PLANNING BOARD REPORT PORTLAND, MAINE

Twelve-Unit Condominium Building
One Joy Place
Subdivision, Level III Site Plan
and Conditional Use Inclusionary Zoning

Project #2017-103 (Subdivision & Site Plan)
Project #2017-128 (Conditional Use Inclusionary Zoning)
CBL: 045 E049001

Submitted to: Portland Planning Board Public Hearing Date: September 26, 2017	Prepared by: Jean Fraser, Planner Date: September 22, 2017
--	---

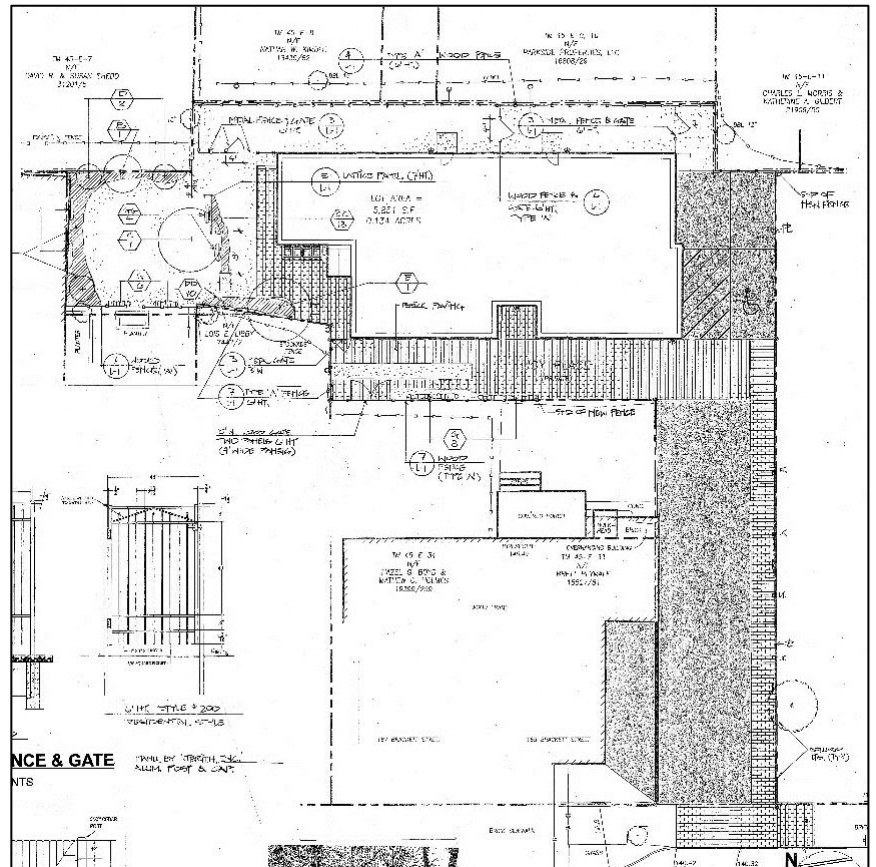
The proposed landscaping has been reviewed by the City Arborist and he recommends substituting a different species of tree for the proposed Amur Maple in the community open area (Attachment 4).

- v. That the Landscaping Plan shall be revised, for review and approval by the City Arborist and Planning Authority prior to the issuance of a building permit, to replace the Amur Maple with a species suggested by the City Arborist in his comments dated 9.21.2017; and
